FREDERICK COUNTY PLANNING COMMISSION

TITLE: **Mayne Property: Preliminary Plan Review**

FILE NUMBER: **S 1157 (PHASE 3 AP#10707 APFO # 10708 & FRO #10709)**

REQUEST: **Preliminary Plan**
Requesting preliminary plan for a 193-unit residential development, comprised of 148 Single-family detached dwellings, 45 Townhouses, (including) 25 Townhouse MPDU's; on a 62.38-acre site.

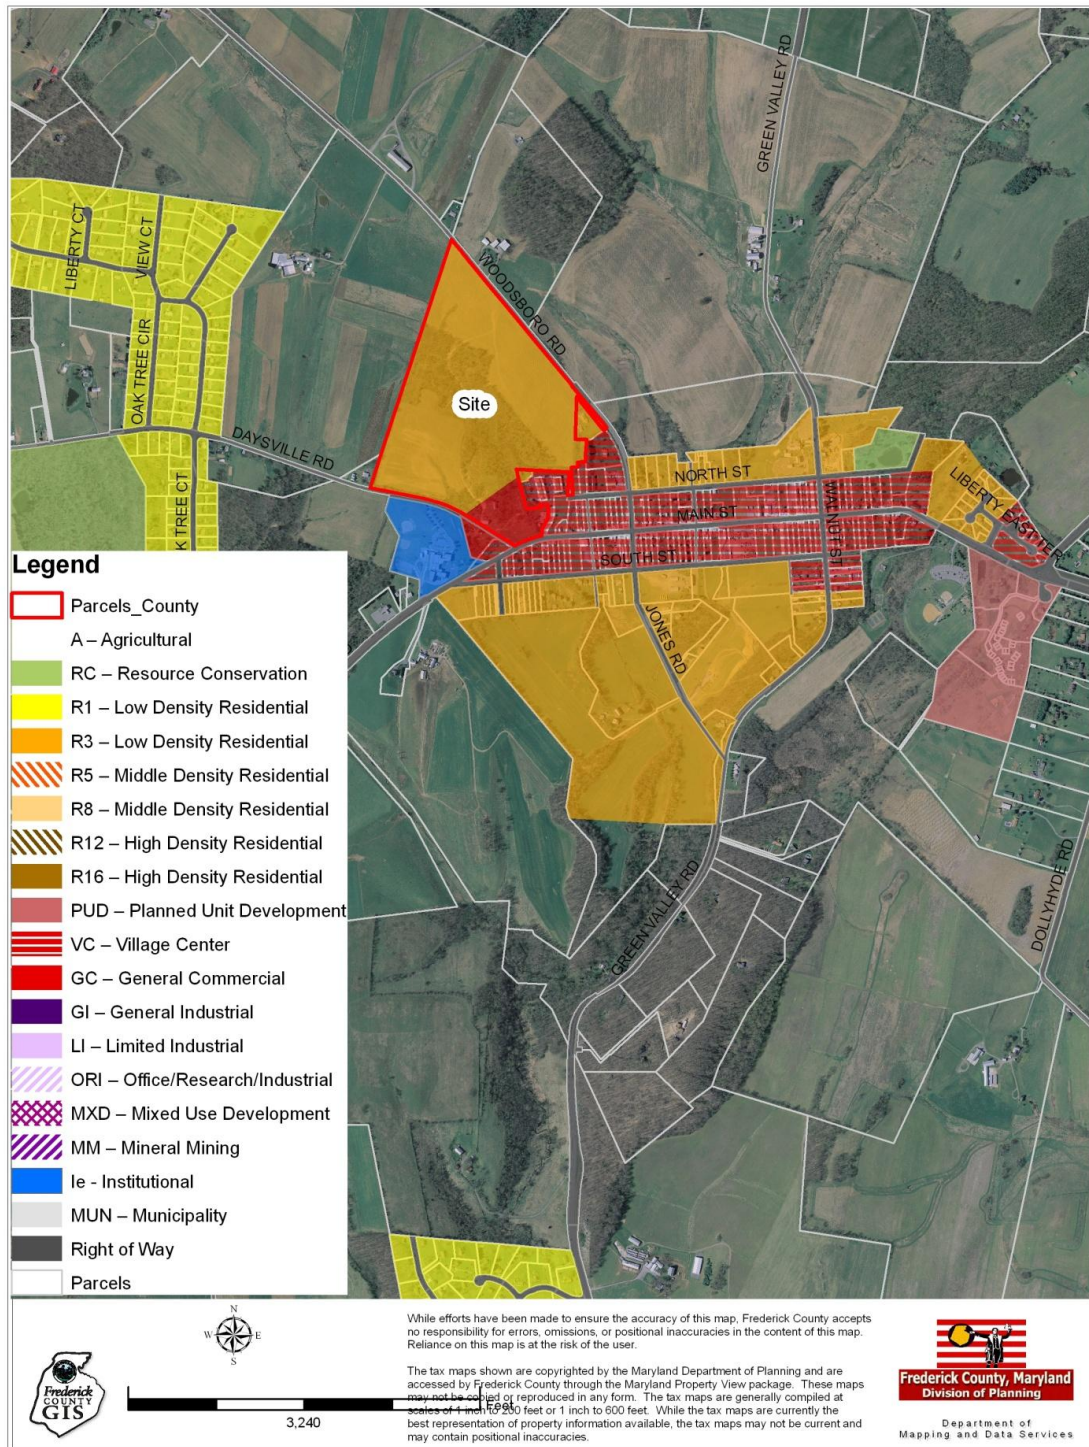
The FCPC did not object to the proposed residential sub-collector shown as "Road E", (*Exhibit #1 within attached August 11, 2010 Staff Report*) in order to achieve the purpose of the Libertytown (MD 26) Bypass. For the purpose of calming travel speeds and discouraging through traffic movements between MD 550 and Daysville Road, two right angle turns were introduced on this "collector" road between Daysville Road and MD 550.

During the Preliminary Sketch Plan meeting, the FCPC did not object to placing a 1.59-acre active recreation field with associated parking across Daysville Road on a separate parcel adjacent to Liberty Elementary School.

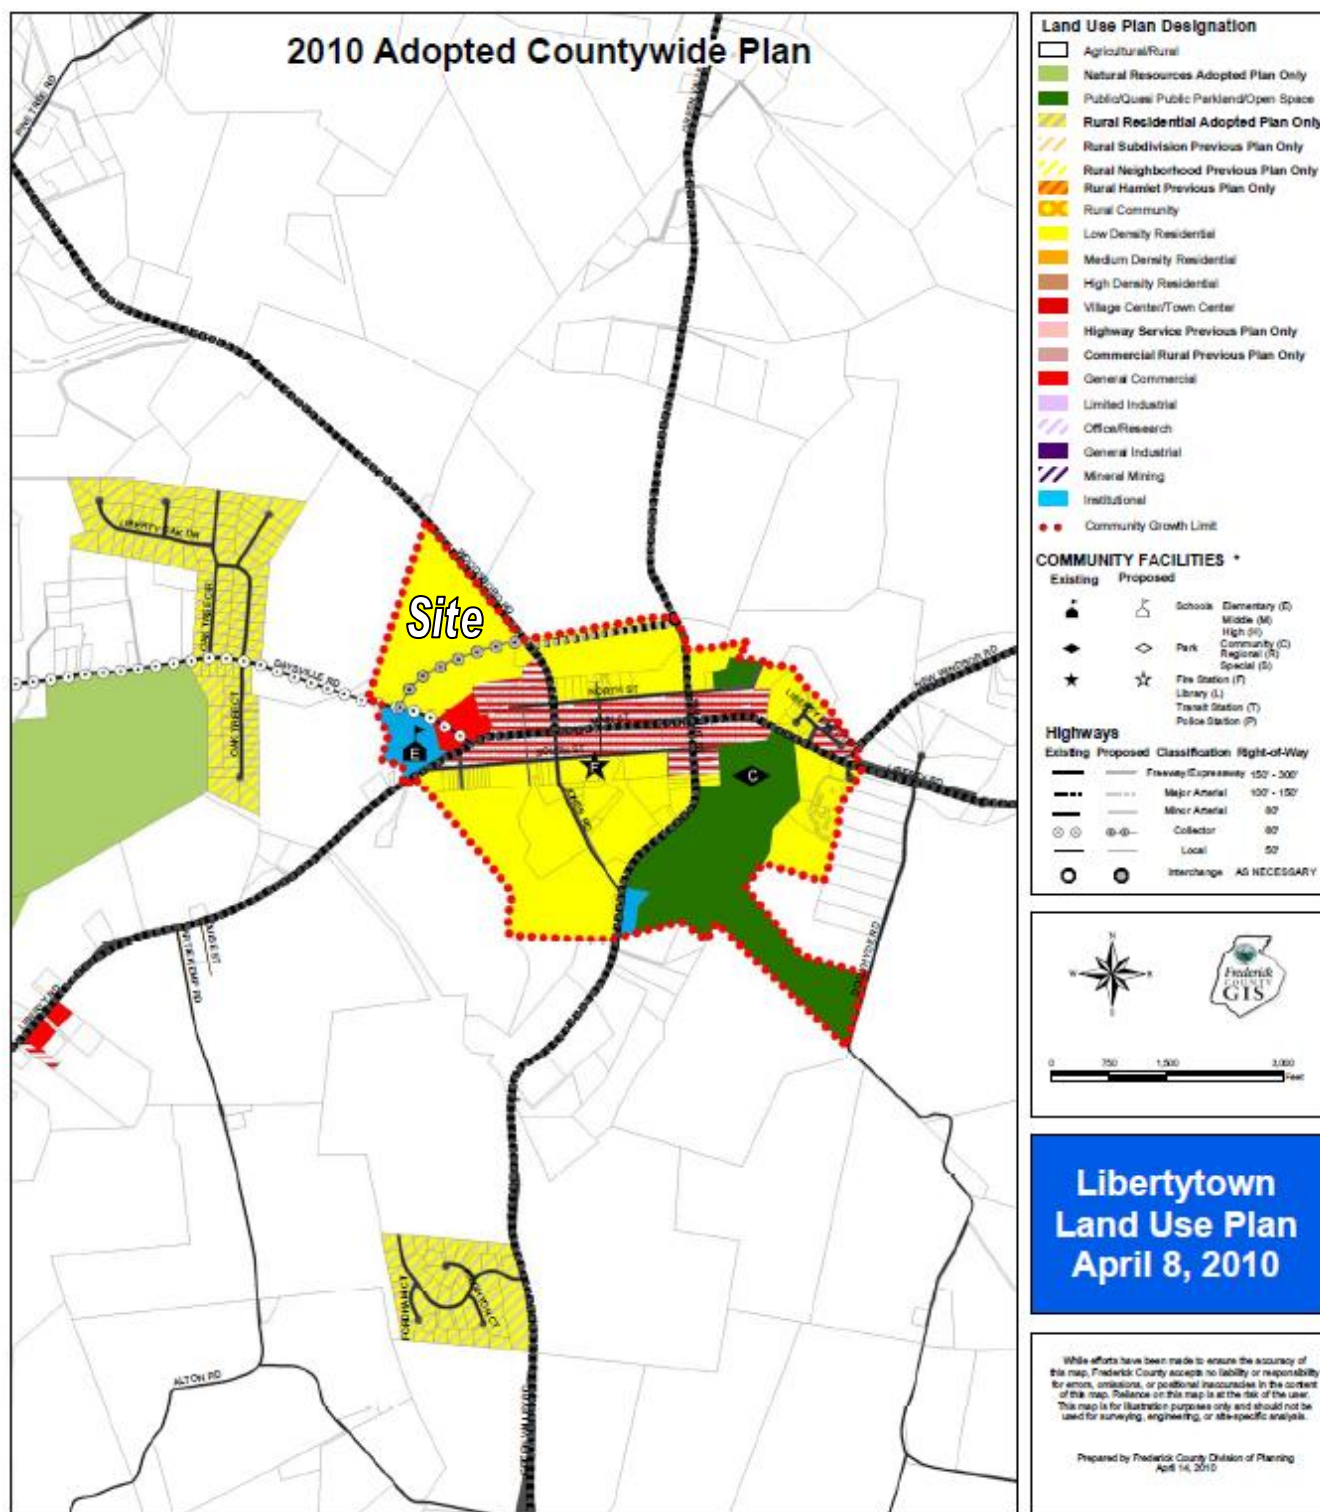
Zoning: The site is split-zoned although the majority is located within the R-3 Residential (R-3) Zoning District, shown in orange. There are approximately 4.95 acres located within the General Commercial Zoning District, shown in red. At the present there are no proposed plans for the 4.95-acre portion of the tract zoned GC.

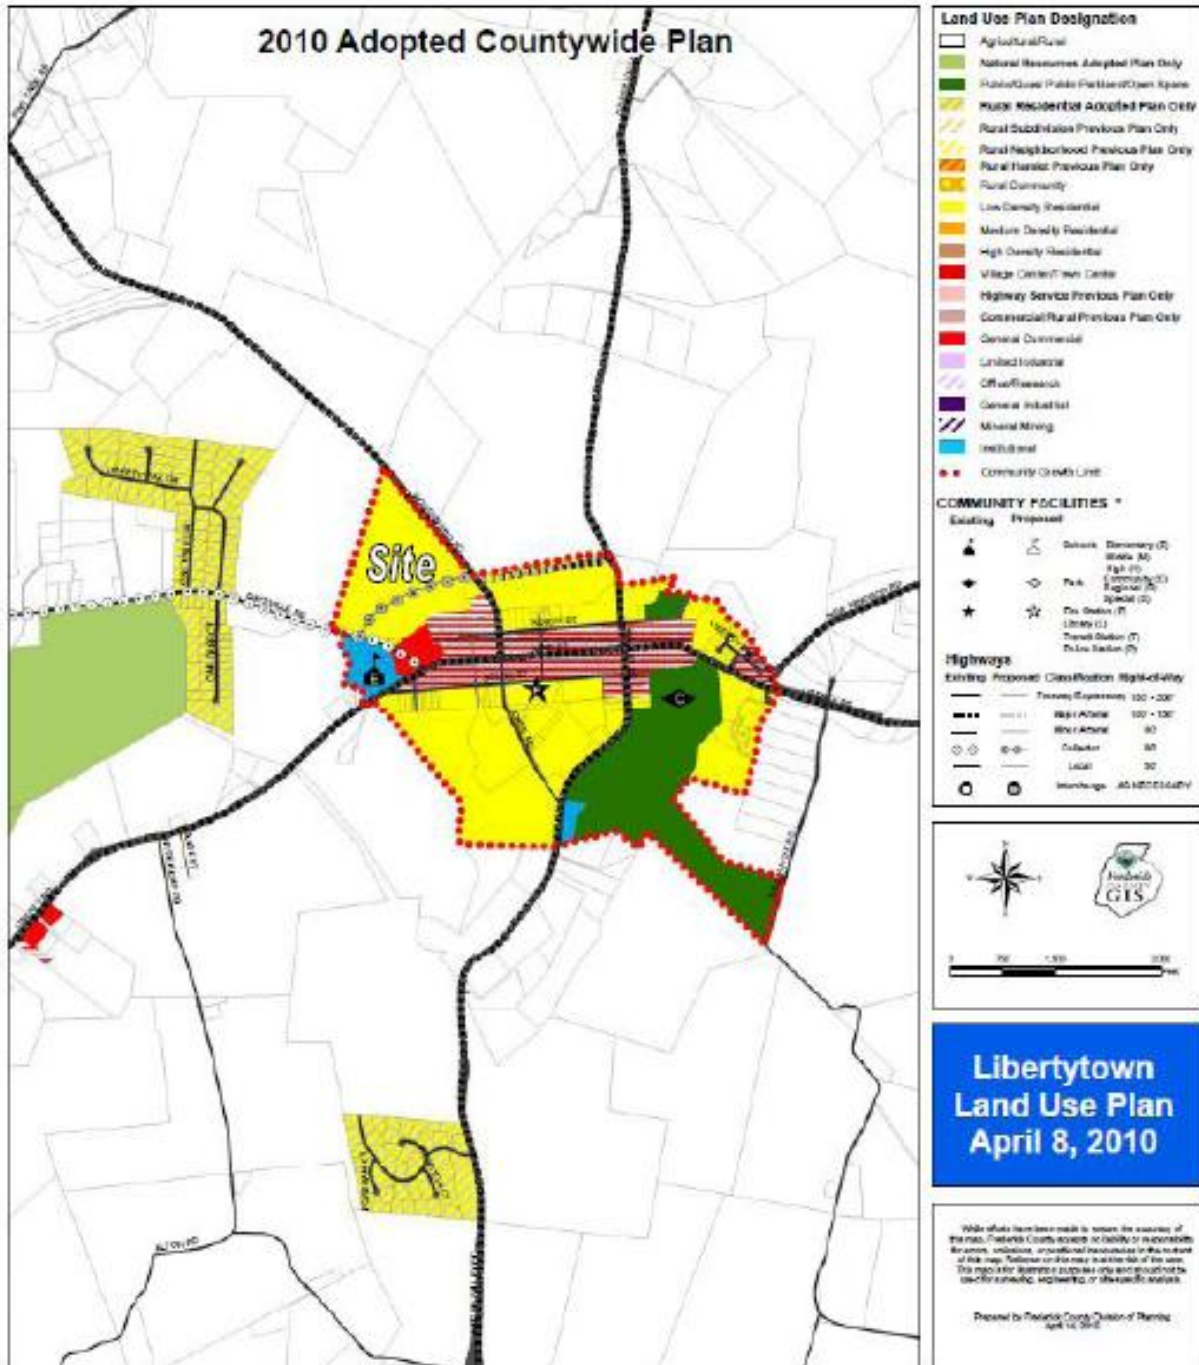
Zoning: The site is split-zoned although the majority is located within the R-3 Residential (LI) Zoning District, shown in orange. There are approximately 4.95 acres located within the General Commercial Zoning District, shown in red.
